**1/24/2020**

The attached record(s) are being provided by the Office of Regulatory Affairs (ORA) Division of Information Disclosure Policy – In response to your request [2020-451] dated 1/13/2020 for record(s) from the Food and Drug Administration pursuant to the Freedom of Information Act regarding:

A copy of any letter from the FDA to Merck regarding any inspection at any time between March 2008 and the present by the FDA of Merck's facility in West Point, Pennsylvania, concerning the Gardasil vaccine; etc

Attached you will find a letter that responds to the FDA Form 483 observations presented at the conclusion of the Team Biologics Inspection at our West Point, Pennsylvania, facility on 17-Jan-2008. After a communication with Ms. Malarkey, she indicated that our response should be directed to your attention.

Figure 1: Regression Analysis of (b) (4) Data in CP9110.780

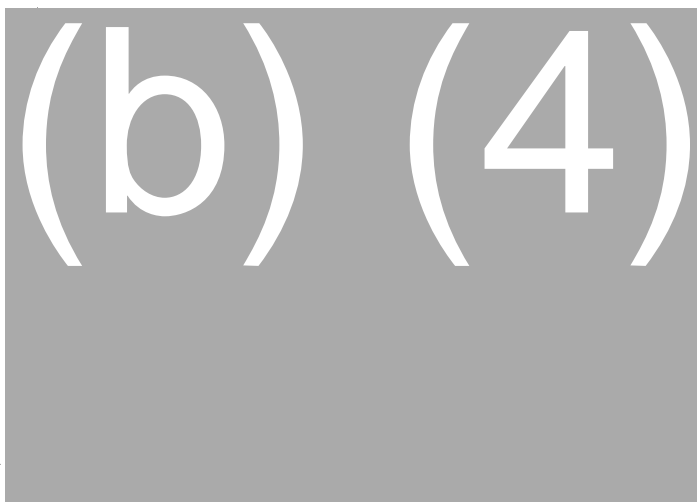
CP9110.780 positive control data are shown in Figure 1. The solid line indicates the linear regression analysis of the (b) (4). The associated (b) (4) is shown in the table below. These data support the conclusion that the RECOMBIVAX HB® Reference Standard Lot 1571L has been stable and continues to maintain the critical performance characteristics required for use.
